SERVICE BULLETIN

from: TRIO-KENWOOD COMMUNICATIONS, INC.

No. 10

SUBJECT: Arcing in TR-7400A final section

✓ L-6

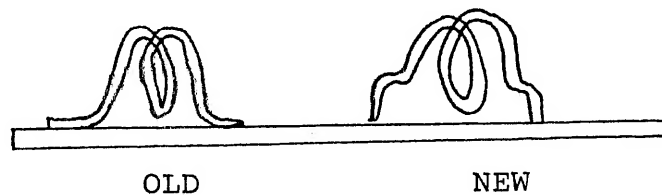
There may be some cases of arcing to ground beneath coil L-6 at the collector of Q-2 (2N6083) inside the final unit X45-1090-10. This is due to minute differences in the circuit board trace dimensions and a residue of flux on the board.

If this should occur, remove L-6 and clean all traces of carbon and flux from the circuit board. Resolder the edges of the tracer and remove any flux left from soldering. Modify L-6 as shown:

Reinstall L-6 and check for rated output. A slight retuning of TC-4 may be required.
